The Village of Little Chute has reviewed the SSA application from Outagamie County Solid Waste and the Regional Plan Commission’s memorandum on the application. Based upon our review, please accept this letter as an official response to the proposed amendment.

RE: Outagamie County Northwest Landfill Appleton SSA Amendment Request, Track No. 162

Appleton & Heart of the Valley Sewer Service Area Amendment

OUTAGAMIE COUNTY NORTHWEST LANDFILL

Appleton & Heart of the Valley Sewer Service Area Amendment

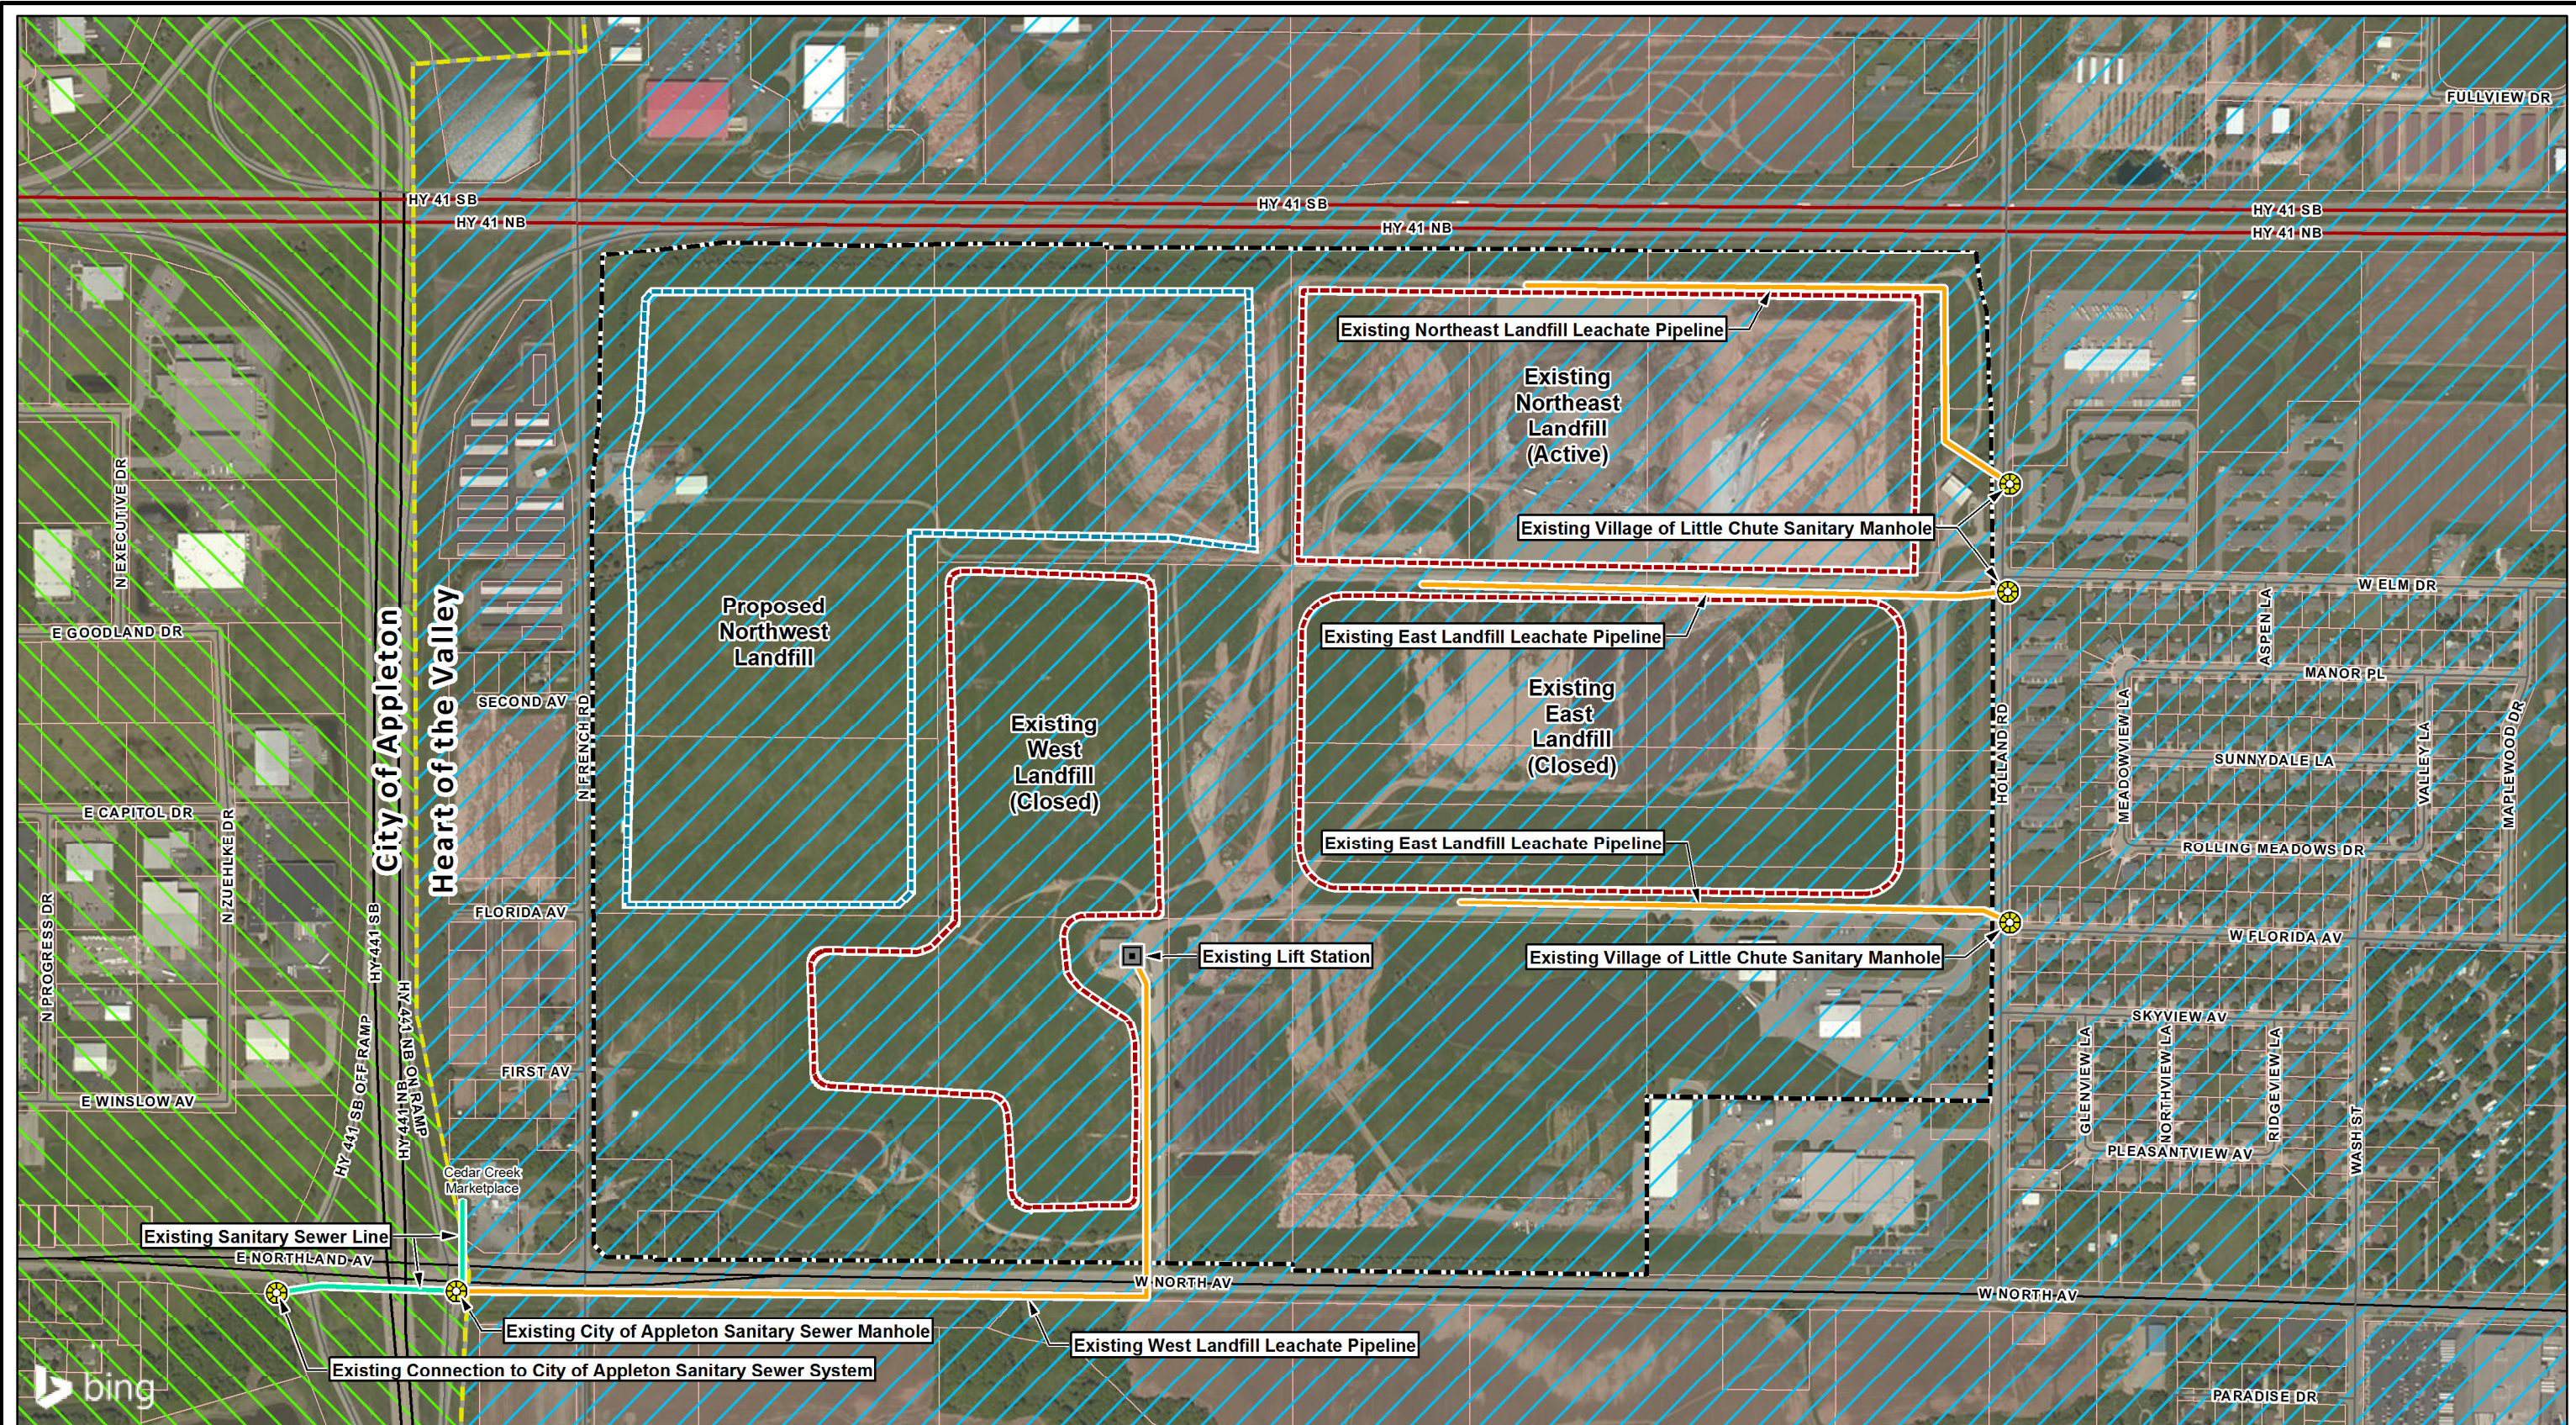
The proposed SSA boundary amendment removes a total of 271.2 SSA & Planning Area acres from the HOV SSA and adds a total of 294.8 SSA & Planning Area acres to the Appleton SSA. The additional 23.6 acres was added as part of the amendment to address property along French Road. This area was not within either SSA or Planning Areas. Until now it was undetermined who (City of Appleton or Village of Little Chute) could cost effectively service this area.
